project  
 Black Country Retrofit Wrap and Associated Works  
 100 - 122 Darlaston Road, Kings Hill, WS10 7SR

title  
 Proposed Second Floor Plan

job	dwg no	rev	date	scale	drawn
18-1540	502	A	Aug 20	1:100 @ A3	RP

SECOND FLOOR PLAN

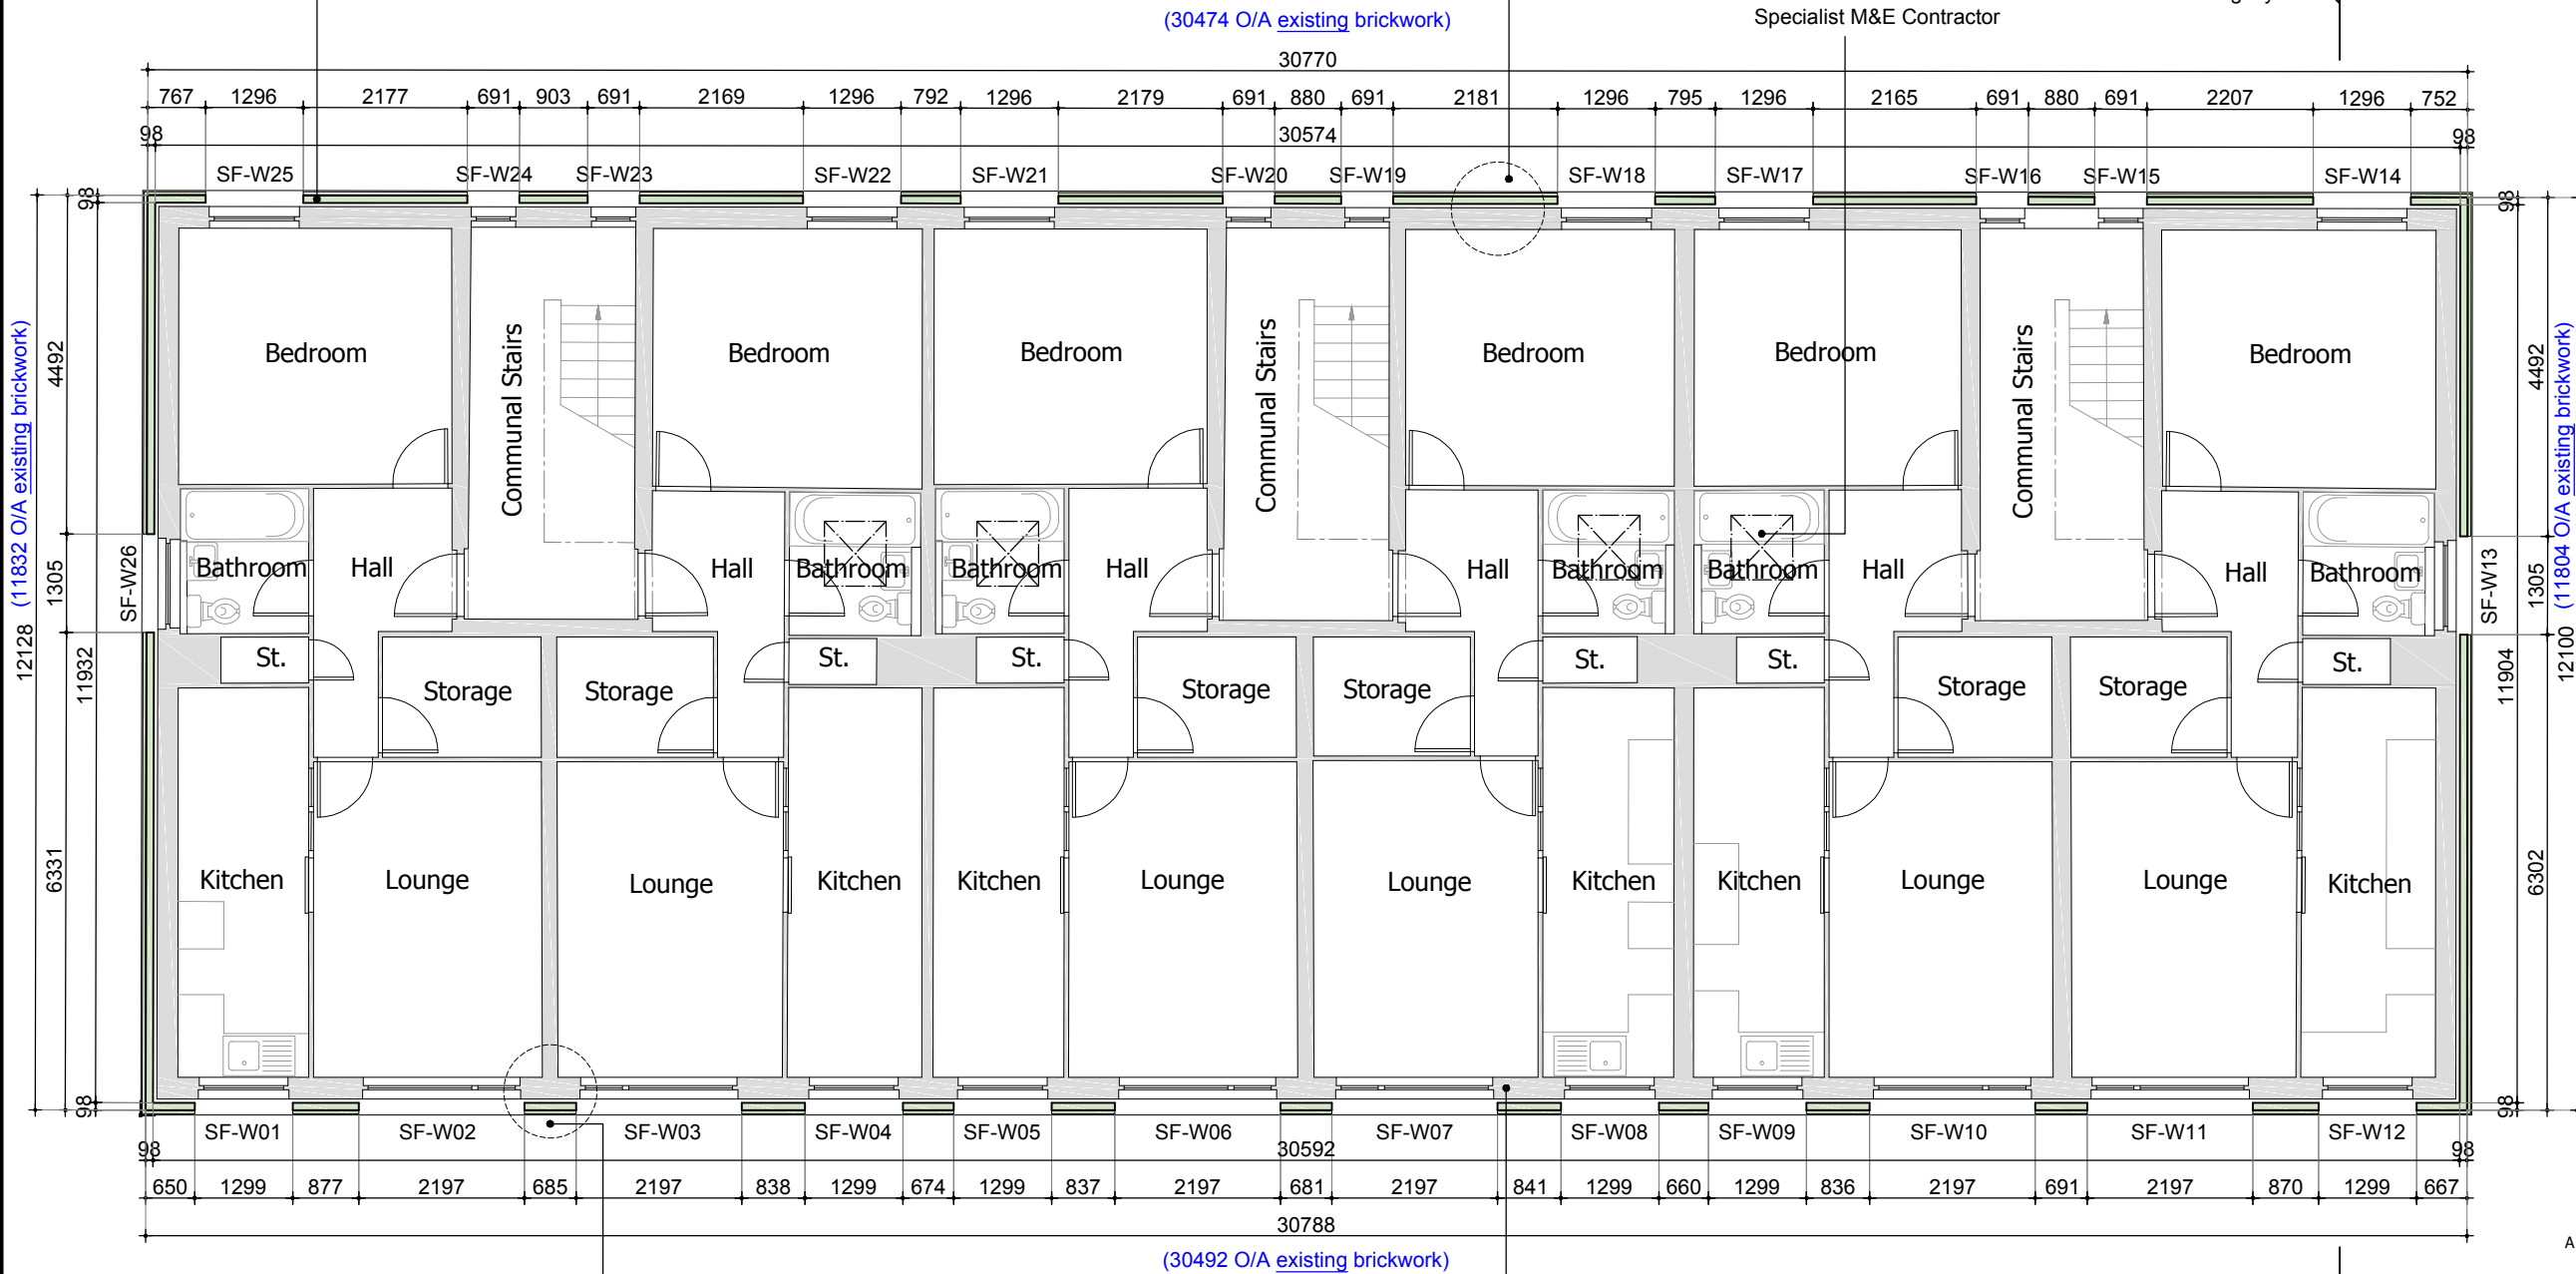
A Notation revised to confirm replacement of roof lights and mechanical ventilation thru walls 25/09/20 RP

Existing roof lights (4no.) to be replaced with new to match existing (to Client's approval).  
 New mechanical ventilation with humidifier sensors to be provided to bathrooms and to extract thru external wall. Extracts to be co-ordinated with Factory panels, and installed and sized to suit horizontal cladding by Specialist M&E Contractor
